HPBC DEVELOPMENT CONTROL COMMITTEE

UPDATES REPORT

HPK/2019/0215 – Land East of Bute Street, Glossop

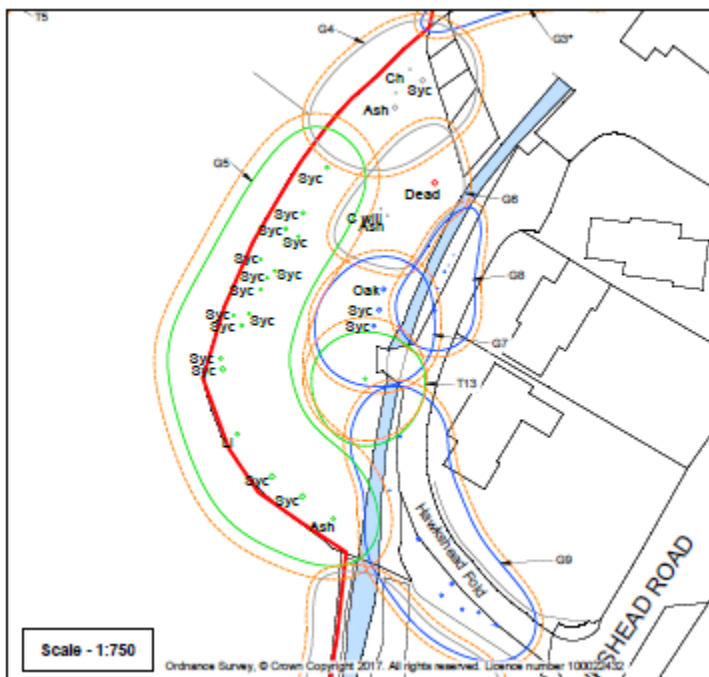
The tree officer has reviewed the updated information and confirms that they have still concerns about the proximity of the development to G4 and G5, two groups of trees on the eastern boundary comprising Sycamore, Ash and Cherry ,which includes mature trees (20m+) which are subject to a TPO (see extract from Arboricultural Assessment below).

The layout plan shows a row of terrace properties up against this boundary. The tree officer is concerned that there would be future pressure to remove the trees which would be positioned to rear of gardens due to shading and considers the proposals contrary to policies EQ2 and EQ9 on this basis.
